Customer Information Letter
Medical Device Correction
860306 Philips PageWriter TC30 Cardiograph
Blank I/O Module

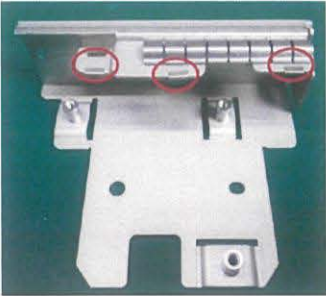
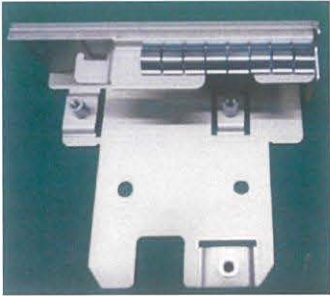
Philips has issued a correction to a manufacturing assembly problem for the 860306 Philips TC30 Cardiograph. Three additional non-functional ground springs on the Blank I/O module could become loose potentially leading to an internal short that could cause the cardiograph to stop working. As of today, we have not received any reports of these additional non-functional ground springs affecting the performance of the device.

ADVICE ON ACTIONS BY CUSTOMER / USER	Upon receipt of this notification, promptly locate your affected device.
ACTIONS PLANNED BY PHILIPS	Philips has issued a correction, free of charge. You will be contacted by a Philips representative to schedule an appointment to perform the removal of the additional non-functional ground springs from your Philips TC30 Cardiograph.
FURTHER INFORMATION AND SUPPORT	If you need any further information or support concerning this issue, please contact your local Philips representative: <Philips representative contact details to be completed by the KM / country>
